**MINOR MODIFICATION  
TO THE  
CROTON WATER TREATMENT PLANT  
FINAL SUPPLEMENTAL ENVIRONMENTAL IMPACT STATEMENT  
CEQR NO. 98DEP027**

**CRO-313 AND CRO-3120S PROPOSED PROJECT DESIGN CHANGES  
AT THE JEROME PARK RESERVOIR SITE**

**April 2009**

**TABLE 1. COMPARISON OF MAIN DESIGN AND CONSTRUCTION CHANGES RELEVANT TO CONTRACTS CRO-313 AND CRO-312OS**

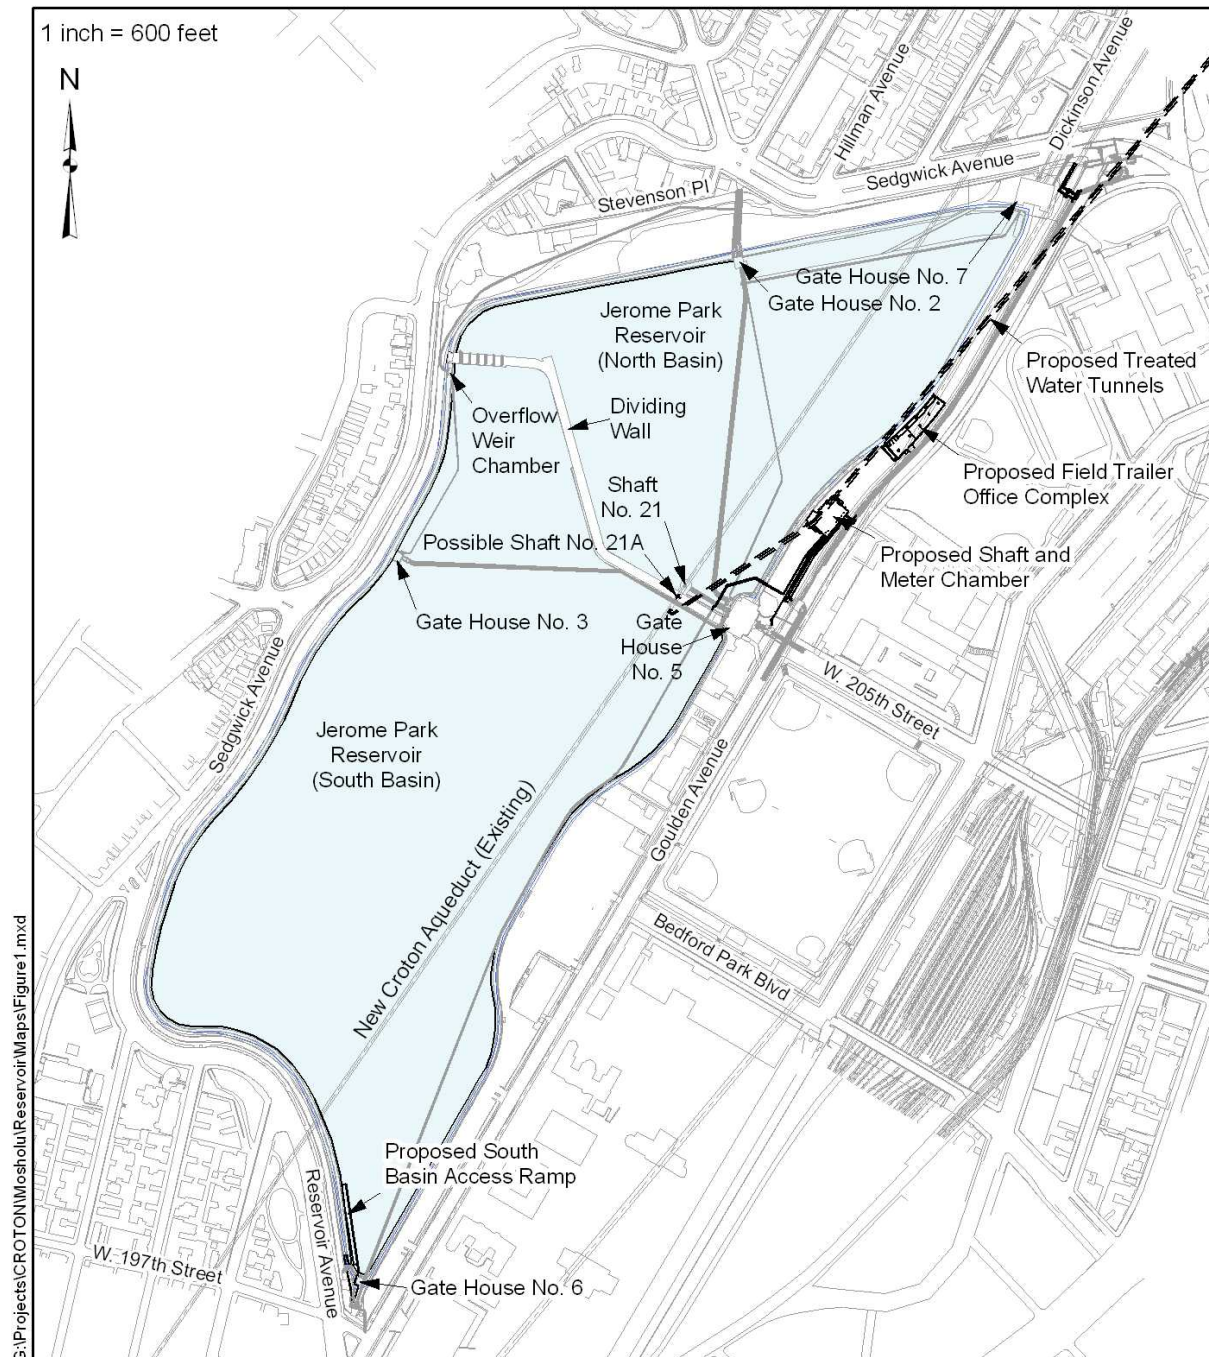
<b>Project Element</b>	<b>Contract</b>	<b>As Discussed in the Final SEIS</b>	<b>As Currently Proposed (Minor Modification)</b>
Approach to Keep Raw and Treated Water Separate in NCA	CRO-313	Utilize the existing Shaft No. 21.	Current design includes the possible construction of a new shaft, Shaft No. 21A, if deemed necessary, on the NCA, within the Reservoir's Dividing Wall; alternative design includes installing a 60-foot plug in the NCA between existing Shaft No. 21 and the Low Level Service connection to the NCA.
Treated Water Tunnel Shafts	CRO-313	One large shaft (30 feet diameter) constructed using the raise bore construction method, which would contain two riser shafts.	Two smaller shafts (each 9 feet diameter) constructed using the raise bore construction method.
New Shaft Chamber	CRO-312OS	Constructed in the Harris Park Annex to house a single treated water tunnel shaft (described above); soil and bedrock removed using mechanical methods.	Modified shaft and meter chamber constructed in Harris Park Annex to house two treated water tunnel shafts and all flow meters; soil removed using mechanical methods, while bedrock removal would be performed by blasting and mechanical methods.

Flow Meter Chambers	CRO-312OS	Two separate Flow Meter Chambers proposed beneath Goulden Avenue, and one Flow Meter Chamber proposed beneath Harris Park Annex south of the Shaft Chamber.	Flow meters would be contained within the single shaft and meter chamber described above; thus, the need for separate Flow Meter Chambers has been eliminated.
Rehabilitation of Gate Houses	CRO-312OS	Rehabilitate interior and exterior of Gate House Nos. 2, 3, 5, 6 and 7.	Only interior rehabilitation will be conducted; no exterior work at this time.
Gate House No. 5	CRO-312OS	Remove existing 16-inch diameter raw water pipe between Gate House No. 5 and the Demonstration Plant.	Removal of raw water pipe is being done under a separate project (CRO-315 – Demolition of the Demonstration Plant).
Gate House No. 2	CRO-312OS	Extend 30-inch diameter drain line from the Jerome Park Reservoir Dividing Wall to Gate House No. 2.	Extension of drain line not required.

Jerome Pumping Station	CRO-312OS	Place off-line; would be used for NYCDEP staff offices.	No longer part of project.
Jerome Park Reservoir Walls and Base Slab	CRO-312OS	No work proposed.	Conduct inspection of the Reservoir walls and base slab; repair as needed.
Emergency Bypass	CRO-312OS	No work proposed.	Current design includes an emergency bypass connecting the shaft and meter chamber to the NCBA; alternative design includes connecting the Shaft and Meter Chamber to Gate House No. 5.
South Basin Ramp	CRO-312OS	Construct ramp in the South Basin in the vicinity of Gate House No. 6.	Construct South Basin Ramp adjacent to Gate House No. 6 along the western wall of the Reservoir; if removal of bedrock is required it would be performed by blasting and/or mechanical methods.

Figure 1

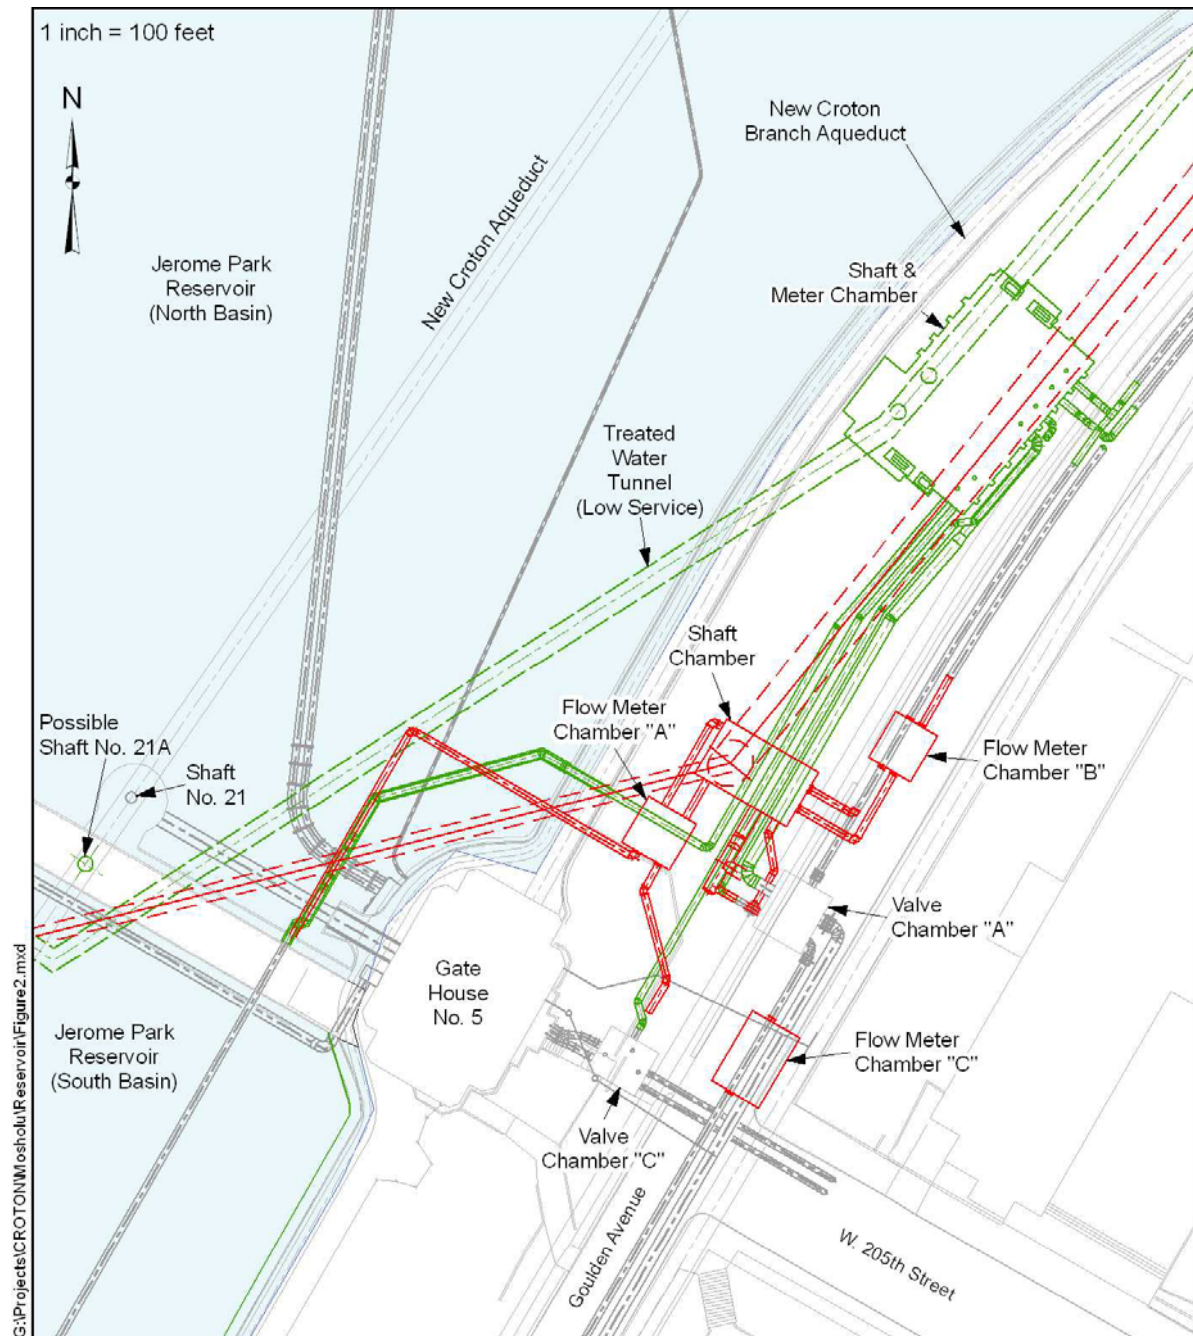
At the time that the Final SEIS was completed, the Croton WTP and associated off-site facility designs were in various stages of design. For instance, the off-site facilities, which had later construction start dates than the WTP, were in more preliminary stages of design than the WTP itself, and, of necessity, the assessments were conducted using the best information and assumptions available at that time. Since completion of the Final SEIS, design has progressed to final design and, as is typical for large scale and complex engineering projects, some changes to the preliminary design and proposed construction methods were made based on information that was previously not available. This section summarizes the changes to design and construction plans that have been identified for the Jerome Park Reservoir area for work relevant to Contracts CRO-313 and CRO-312OS. Table 1 provides a comparison of the main design and construction elements for both contracts that are the subject of this Minor Modification, as discussed in the Final SEIS and as currently proposed. Overall project elements and work locations are identified on Figure 1, while Figure 2 provides a more detailed layout of the proposed Shaft and Meter Chamber area.
